RE: Development Impact Assessment and Tree Preservation Guidelines:  
Twin Rivers Project, Sacramento

**DEVELOPMENT IMPACT ASSESSMENT AND  
TREE PRESERVATION GUIDELINES:  
TWIN RIVERS PROJECT, SACRAMENTO**

I reviewed the conceptual grading and drainage and utility plans drafted by Cunningham Engineering dated May 25, 2017. I also reviewed a tree removal exhibit Cunningham prepared on May 30, 2017 (attached).

DESIGNED BY: CK	DRAWN BY: KD	CHECKED BY: DF	SCALE: 1" = 60'
	APPROVED BY:	REVISIONS:	NO.:	DATE:
<p><b>TREE REMOVAL EXHIBIT</b> FOR <b>TWIN RIVERS REDEVELOPMENT</b></p>				
SACRAMENTO CALIFORNIA				
<p>SHEET <b>1</b> OF <b>1</b></p>				
DATE: 05/25/2017				
JOB NO: 1587.00

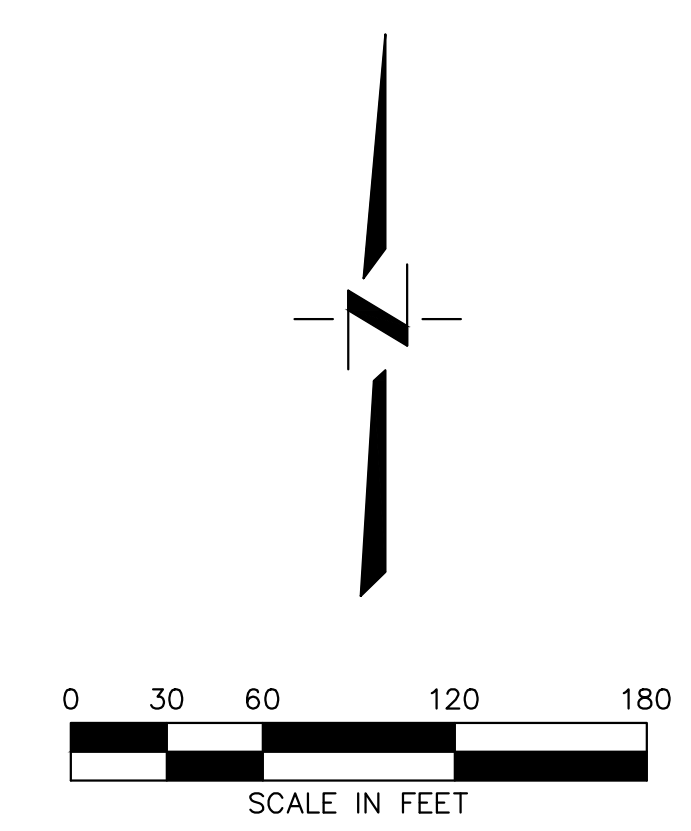
Forty-two of the 130 trees on site (32%) were shown to be retained (protection zones marked green on the Tree Removal Exhibit). Eighty-eight of the trees were to be removed, as shown with X's on the plans and red protection zones on the exhibit described above. Fourteen of the trees to be removed were not considered "protected trees."

I recommended that 34 of the remaining 74 protected trees be removed because either 1) their health was failing and/or 2) they had uncorrectable safety concerns (marked red *with* a red X on the tree removal exhibit). I was asked to provide a development impact report for the 40 trees that remained which were to be removed due to site layout conflicts.

Tree #	TPZ (ft.)	Description of Construction within TPZ	Impact Rating	Possible Design Modifications
721	39	Sidewalk, planter and roadway 9.5' NW	High	
723	39	Within stormwater planter on road corner	Removal Necessary	
729	27	In tree lawn; roadway 2' W; sidewalk 4' E; fire hydrant 17' N	Extreme	Maintain existing curb; install walk on grade with no scarification.
730	40	In tree lawn; roadway 4' W; sidewalk 4' E; stormwater planter 9' N; fire hydrant 37' south	Extreme	Move stormwater planter. Maintain existing curb; install walk on grade with no scarification.
731	26	Within stormwater planter; roadway 8' W; sidewalk 5' E	Removal Necessary	
732	27	Roadway 2' W; sidewalk 5' E	Extreme	Maintain existing curb; install walk on grade with no scarification.
733	30	Roadway 2' W; sidewalk 5' E	Extreme	Maintain existing curb; install walk on grade with no scarification.
734	30	In roadway	Removal Necessary	
735	31	Within stormwater planter; roadway 8' W; sidewalk 5' E; building 22' E; SD 24' NE	Removal Necessary

736	28	Roadway 2.5' W; sidewalk 5' E; SD 20' E; building 25' E	Extreme	Maintain existing curb; install walk on grade with no scarification; minimize extent of excavation; avoid grading in as much of TPZ as possible - use retaining wall.
737	48	Roadway 2.5' W; sidewalk 4' E; building 22' east	Extreme	Maintain existing curb; install walk on grade with no scarification; minimize extent of excavation; avoid grading in as much of TPZ as possible.
738	28	Fire hydrant 2' SW; roadway 7' west; sidewalk 5' east; building 25' east	Extreme	Maintain existing curb; install walk on grade with no scarification; minimize extent of excavation; avoid grading in as much of TPZ as possible - use retaining wall; move hydrant.
739	28	Roadway 4' W and 17'N; sidewalk 5' E; stormwater planter 19' NE; building 23' E	Extreme

Tree #	TPZ (ft.)	Description of Construction within TPZ	Impact Rating	Possible Design Modifications
740	26	Roadway 2' W; sidewalk 6' E; stormwater planter 2' S; building 21' E	Extreme	Move stormwater planter; maintain existing curb; install walk on grade with no scarification; minimize extent of excavation; avoid grading in as much of TPZ as possible use retaining wall.
741	27	Fire hydrant 4' SW; roadway 5' west; sidewalk 4' E and 17' N; building 19' E	Extreme	
743	33	Buildings 21' SW and 23' SE; stormwater planter 12' S; sidewalk 14' NE	High	Move stormwater planter. Install walk on grade with no scarification; minimize extent of excavation; avoid grading in as much of TPZ as possible use retaining wall.
744	34	Building 16' S	High	Move stormwater planter. Install walk on grade with no scarification; minimize extent of excavation; avoid grading in as much of TPZ as possible use retaining wall.

765	35	Within sidewalk	Removal Necessary	
766	39	Sidewalk 30' NW; fire service 35' W	Low/ Moderate	
767	36	Within roadway	Removal Necessary	
768	25	Within roadway	Removal Necessary	
772	50	Sidewalk 12' N; roadway 29' N	High	Maintain existing curb; install walk on grade with no scarification
779	45	Within roadway	Removal Necessary	
785	31	Bldg 3' NW; stormwater planter 6' N; drain line 6' E	Removal Necessary	
786	29	Under building	Removal Necessary

Tree #	TPZ (ft.)	Description of Construction within TPZ	Impact Rating	Possible Design Modifications
789	40	Building 2' S	Removal Necessary	
793	46	Within roadway	Removal Necessary	
795	37	Under building	Removal Necessary	
796	39	Within parking lot	Removal Necessary	
802	25	Under building	Removal Necessary	
803	43	Building 7' N; parking lot 8' S	Removal Necessary	
805	44	Under building	Removal Necessary	
806	29	Buildings 18' N and 25' W; stormwater planter 2' W; grade to be raised >2'	Extreme	Move stormwater planter. Minimize extent of excavation; avoid grading in as much of TPZ as possible; use retaining wall.
807	32	Within stormwater planter; grade to be raised >3'	Removal Necessary	Move stormwater planter; avoid grading in as much of TPZ as possible; use retaining wall.
808	46	Sidewalk 20' N; grade to be raised 2'	High	Avoid grading within as much of TPZ as possible; use retaining wall.
812	40	Within roadway	Removal Necessary

824	62	Within stormwater planter; 6' from walk; 23' from curb	Removal Necessary	Move stormwater planter; avoid grading in as much of TPZ as possible; use retaining wall; install walk on grade or if fill, utilize coarse, well drained medium.
825	36	Within sidewalk.	Removal Necessary

Tree #	TPZ (ft.)	Description of Construction within TPZ	Impact Rating	Possible Design Modifications
826	39	Sidewalk 10' N	High	Install walk on grade or if fill, utilize coarse, well drained medium.
829	25	Within sidewalk.	Removal Necessary

- Modify plans where possible considering the design modifications provided.
- Have me review any updated plans and update the Impact Assessment as necessary.
- Where the plan is not adjusted, remove trees with “High” or “Extreme” impact ratings as these trees will very likely die or topple following construction, especially those rated “Extreme.”  
*If any of these trees are to remain, construction work should be supervised by a Certified Arborist who will determine whether injury to roots will require the removal of the tree for safety reasons.*

- Indicate surveyed trunk locations and tree protection zones (TPZ's) as described in attached table on all construction plans for trees to be preserved. Note, where infrastructure is located within protection zones, indicate the *modified* protection zone (MTPZ) as close to infrastructure as possible (minimize extent of excavation and grading; use retaining walls as necessary).
